TO: **Amy Hodgen (Statutory Planning)**
FROM: **Blake Farmer-Bowers (Open Space) and
Christian Lundh (Urban Design)**
DATE: 11 November 2020
SUBJECT: 640 Heidelberg Rd, Alphington - Village Precinct
APPLICATION NO: PLN17/0703.02
DESCRIPTION: Construction of a mixed use multi-storey development in the Village Precinct of the Alphington Paper Mills development comprising dwellings, retail spaces, vehicle access, car parking, streetscapes, public accessible private landscape areas, roof top terraces and vertical greenery.

6. Outer Circle Mews

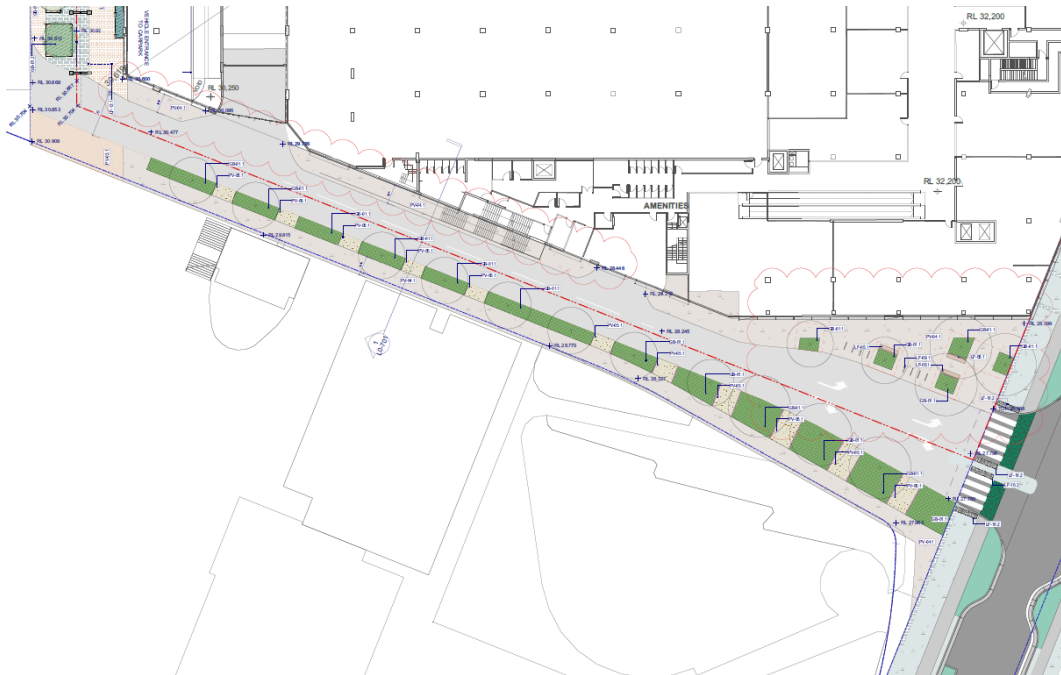
The layout shown is not yet acceptable from an Urban Design and Open Space perspective. Concerns include but are not limited to the items listed below;

- Legibility of plans, the material tags and other notes are overlapping and plans are not legible for Council to make an informed decision on the proposed design; and
- Avoid small 'left over' spaces between street furniture and garden beds.

- Rationalise design to reduce the amount of furniture and fixtures and to maximize planted areas and greenery.

8. Level 01 Terrace

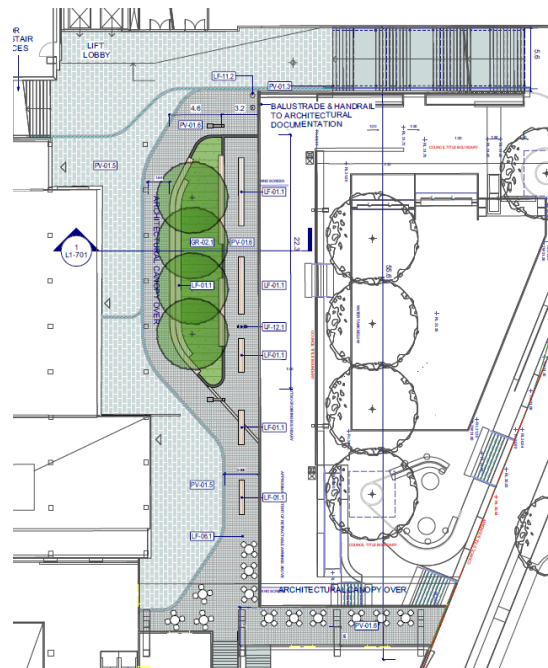
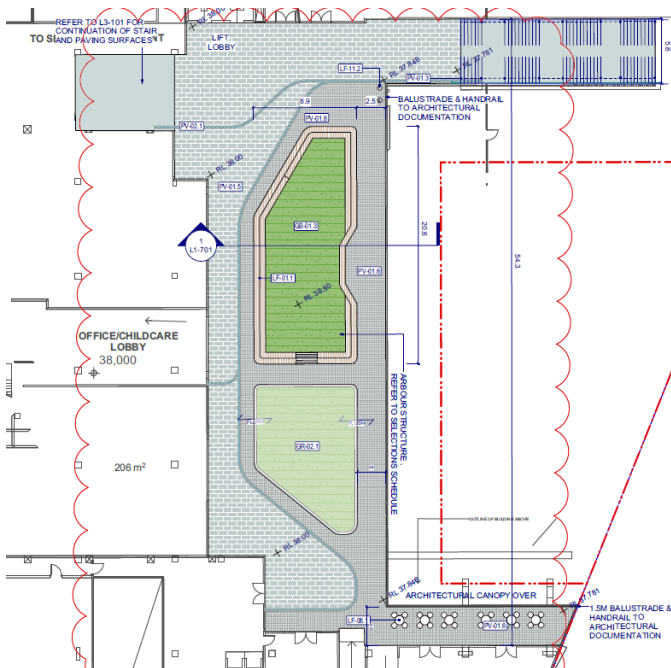
The layout shown is not yet acceptable from an Open Space perspective. Provide a short statement about how the design response addresses the revised functionality of the adjacent buildings and level 01 terrace. For example should this space be conducive for pre-school children rather than primary school children.

- The proposed arbour structure (indicated only with a note on the plan) is in principle not supported as it is assumed to replace the previously proposed trees (trees as shown in superseded design below right);
- Levels shown on plan does not match the section on LA-701; and
- Clarify GR-02.1 missing from legend.

- Consider ergonomic seats with back facing park;
- Re-introduce seating where people can face one another to promote social interaction; and
- Re-introduce trees (shown in previous design refer below right) in lieu of the arbour structure.

9. Level 03 Paper Trail

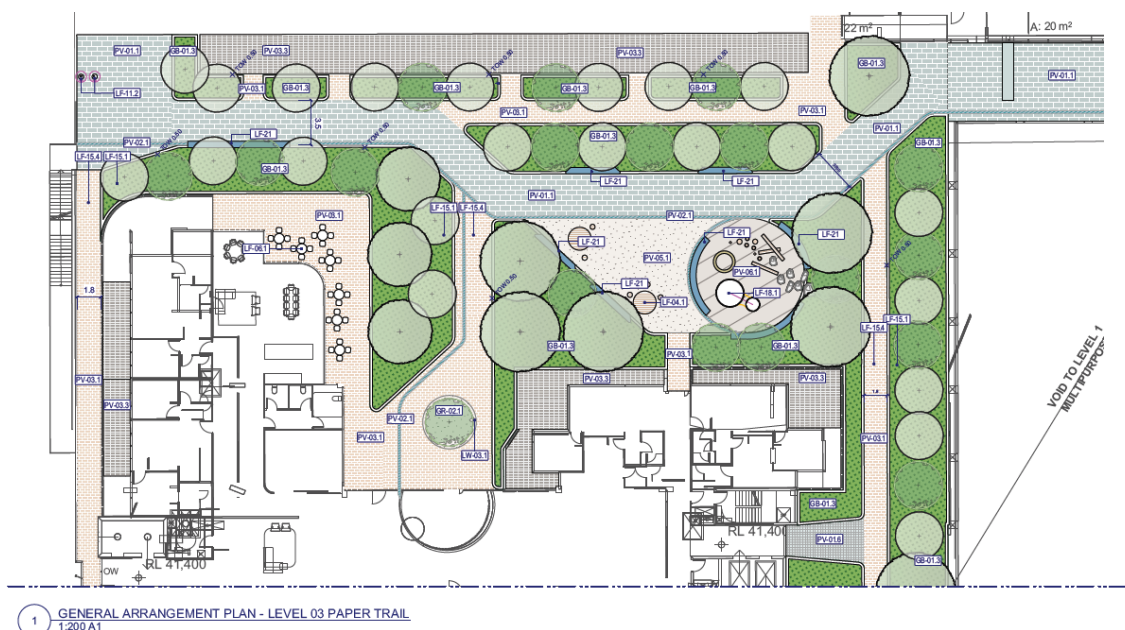
The layout shown is not yet acceptable from an Open Space perspective, concerns relate to the following items;

- Show any security gates;
- Public lift not shown;
- Confirm suitability of gravel pavement PV-05.1 on podium;
- Provide safety assessment of any publicly accessible play area, (by an external certified safety auditor);
- Show all required playground fall zones and clear zones; and
- Confirm suitability of a steel bench by the playground.

Village Square

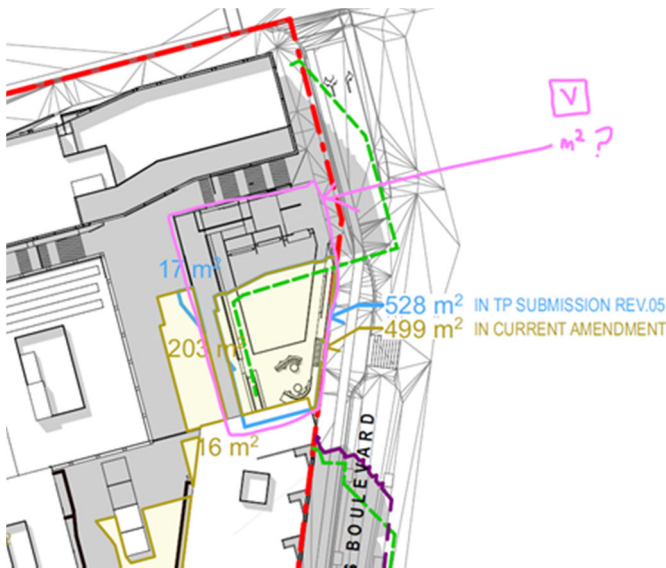
- Provide updated table/data and comparison diagrams that relates directly to the **700m²** minimum requirements of the Village Square as indicated in the sketch below in pink. The numbers in table below are assumed to relate to both the square and the abutting surrounding areas.
- Given that the design of the Village Square is not confirmed, it is not possible to evaluate if solar access provided is within areas of need/benefit.
